UNITED STATES PATENT AND TRADEMARK OFFICE

Office Action Summary	Application No. 10/772,764	Applicant(s) HOGENDIJK ET AL.	
	Examiner Vy Q. Bui	Art Unit 3773

DETAILED ACTION

Limon-'910's Fig. 10

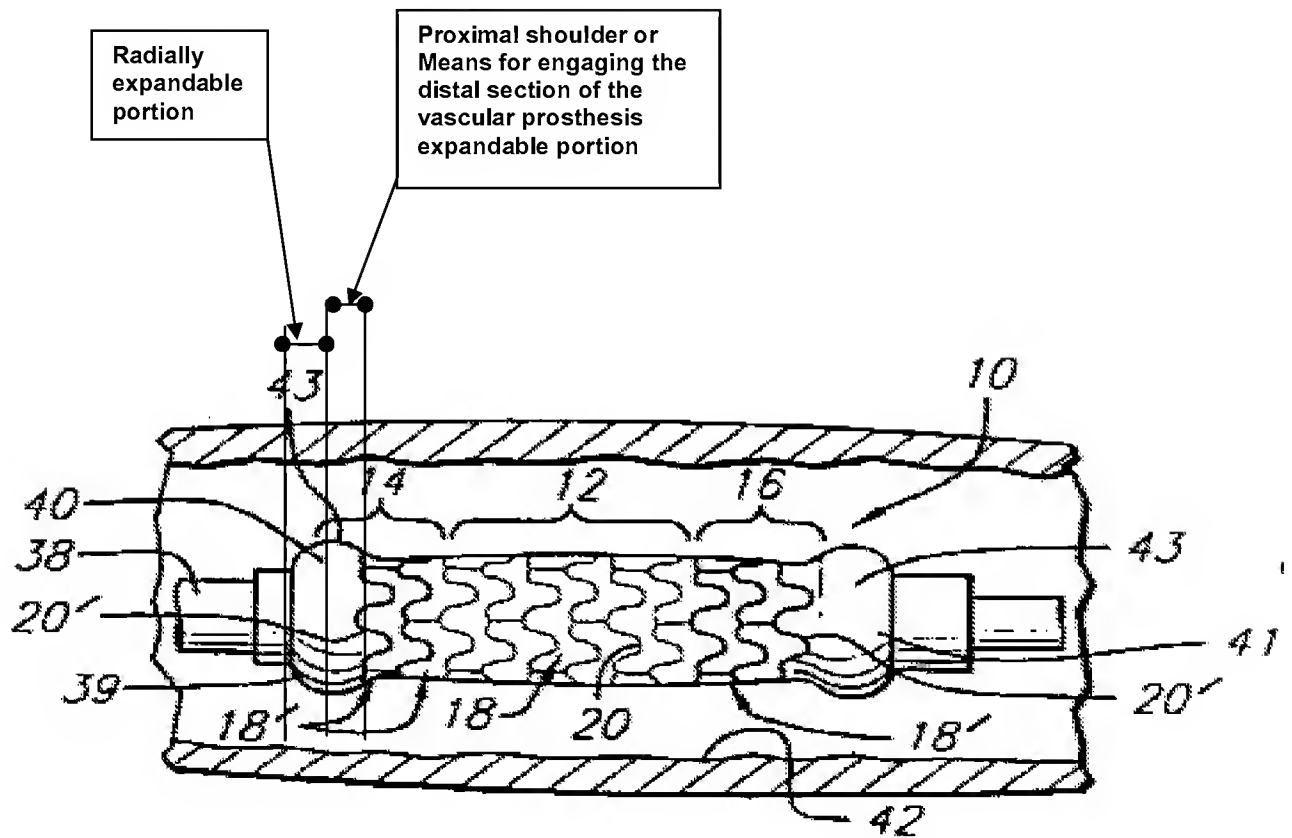
As to claims 1-8, 10-15, Limon-'910 (Figs. 1, 2 and 10; col. 8, lines 36-53) discloses a balloon catheter for an angioplasty procedure comprising elongated member 38, balloon 40 having ridges/collards/polymer layers/shoulders/raised features 43 as means for engaging the distal section of a vascular prosthesis and sheath 46 substantially as recited in the claims.

Notice that the limitation "a radially expandable portion" as recited in independent claims 1 and 11 only requires "a portion" and not "a whole radially expandable length" of the balloon. Further, the radially expandable portion of balloon 40 as shown below can be considered as a distal portion of balloon 40, therefore, it is reasonable to consider the portion of balloon 40 as shown below as a proximal shoulder of balloon 40 and Limon-'910's Fig. 10 includes "a radially expandable portion" and "proximal shoulder or means for engaging the distal section of the vascular prosthesis" as shown below:
